BITTERROOT VIEWS II FIVE-LOT MINOR SUBDIVISION

STAFF REPORT FOR BOARD OF COUNTY COMMISSIONERS

: Meldrum's cleaning system File Name

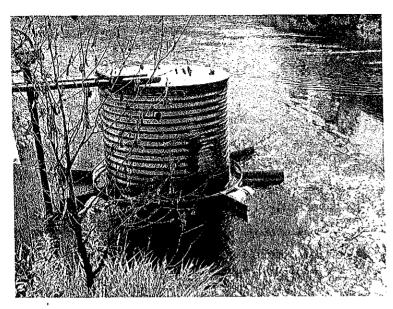
Bitter Root Irrigation District (BRID) would like to see a new cleaning system installed to replace the old system that is presently in use.

The present private irrigation system is very old, outdated, and requires a person hired by the home owners association to remove and replace a heavy 50 pound screen once a day. Bitter Root Irrigation District's operating policy states "the District can not grant permission to third parties to use the district-right-of-ways for any purpose." If the cleaning of the screen doesn't happen the district office receives phone calls for pressure loss to their irrigation system due to a clogged screen. The ditch rider is not responsible for this task.

The District has received several complaints from the existing Robert Meldrum subdivision Homeowners association due to irrigation pressure loss. The proposed Robert Meldrum subdivision would only compound this matter. This is a private system that BRID is not responsible for.

(notice debris from 2008 irric

(Notice build up of algae on:

- 13. The subdivider shall install a new cleaning system as part of the irrigation infrastructure improvements for the existing private irrigation system provides water to the proposed site. The cleaning system shall be reviewed and approved by BRID, and the subdivider shall provide a letter from BRID stating that the system has been installed conformance with the approved design. (Section 3-2-8(b)(v), RCSR, Effects on Agricultural Water User Facilities)

Picture 4 recommended system

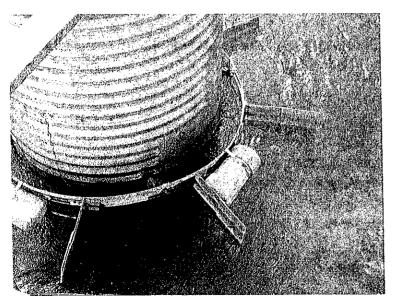
All private systems that use BRID water have a system out in the main canal that uses the water current to keep the intake system clean. I will attach some pictures of the present system and the recommend system. Pictures 1 and 2 show the present system. Pictures 3 and 4 show a recommended system
